Car Stereo Service Bulletin

CSA-14

No. 369

Subject: Display Shows RESET, Disc # 10 Not Ejected.

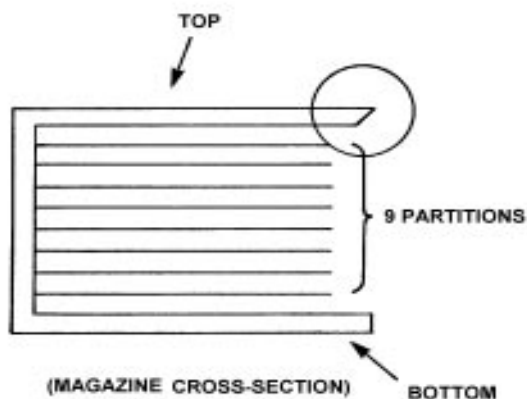
The display on the controller shows "RESET". When the magazine is ejected, disc # 10 remains loaded in the mechanism. This problem may be caused by disc # 10 hitting the front edge of the magazine top cover as it is being returned to the magazine. This problem is more likely to occur when the changer is installed vertically rather than horizontally. When this problem occurs, **models prior to the CDX-45/65** will have disc # 10 **loaded and chucked**. **CDX-45/65 and later models** will have disc # 10 **loaded but it will not be chucked**. If the disc is chucked in the CDX-45/65 and later models, the problem is caused by something other than the magazine (for example, mis-operation of the magazine detect switch).

Replace the customer's magazine with a new one which has a beveled front edge as shown below.
